Product Change Notification / ALAN-09EMDP790

CCB 6482 Initial Notice: Qualification of new lead frame with 96x190 mils lead frame paddle size for selected MIC38Hxx, MIC580xx, MIC258xx, and MIC256xx device families available in 14L SOIC (.150in) package at MMT assembly site.

Pre and Post Change Summary

Pre Change

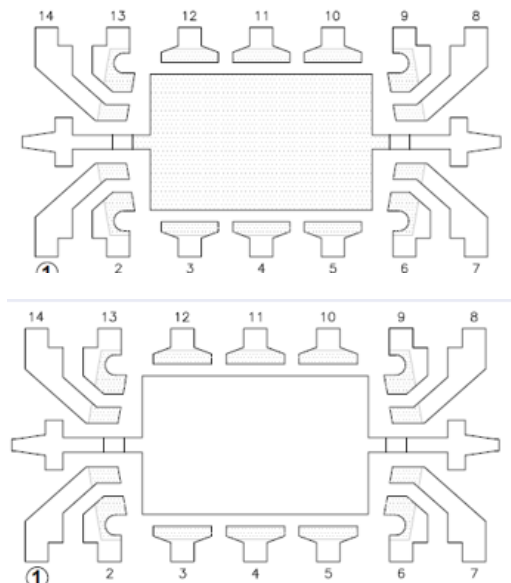
Lead-Frame Paddle Size	95x155 mils	
DAP Surface Prep	Ag Spot	Bare Cu
Lead-frame Treatment	None	BOT
Lead-frame Process	Stamped

Post Change

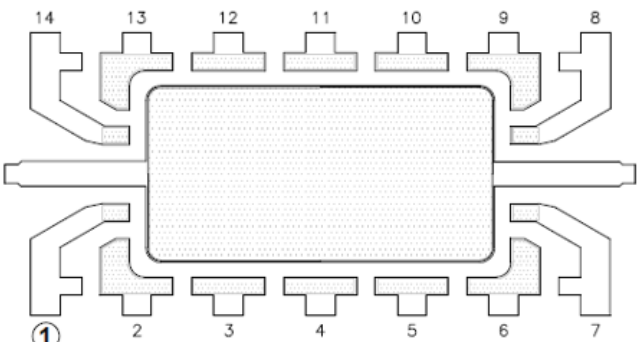
Lead-Frame Paddle Size	96x190 mils	
DAP Surface Prep	Ag Spot	
Lead-frame Treatment	BOT	
Lead-frame Process	Etched
